#### ADDENDUM NO. 1

#### **ECP GATE 7 APRON REPAIR PROJECT**

Date of Issue: November 3, 2021

This Addendum consists of changes to Special Conditions 6 and 7, and changes to Drawings sheet C-3.

Sheet C-3

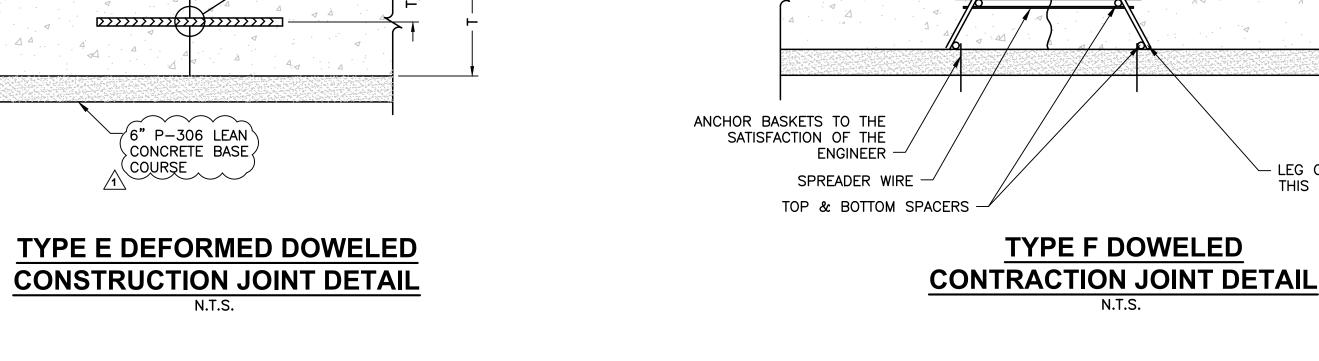
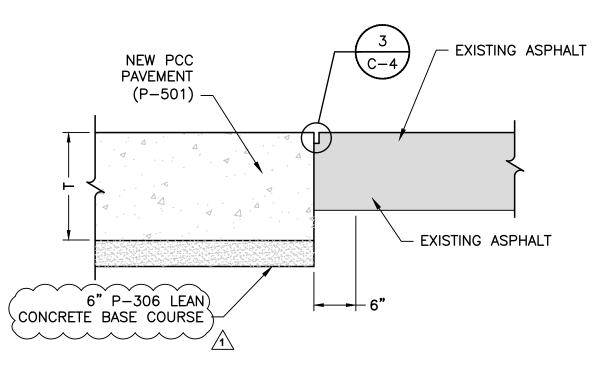
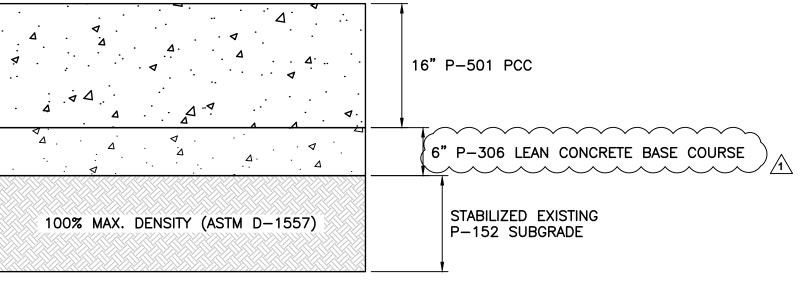
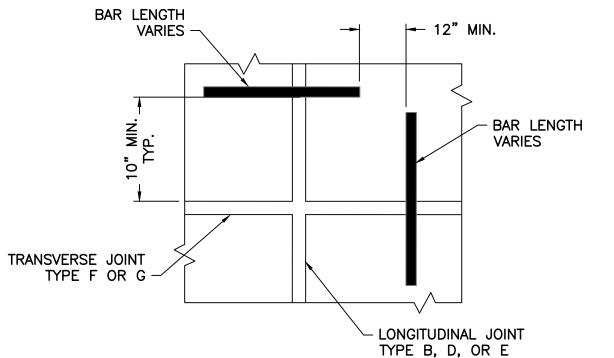
Change to the Drawings Sheet C-3
 REPLACE Sheet C-3 in its entirety with the attached Sheet C-3 hereto. Change revises P-306.

6" P-306 LEAN CONCRETE BASE
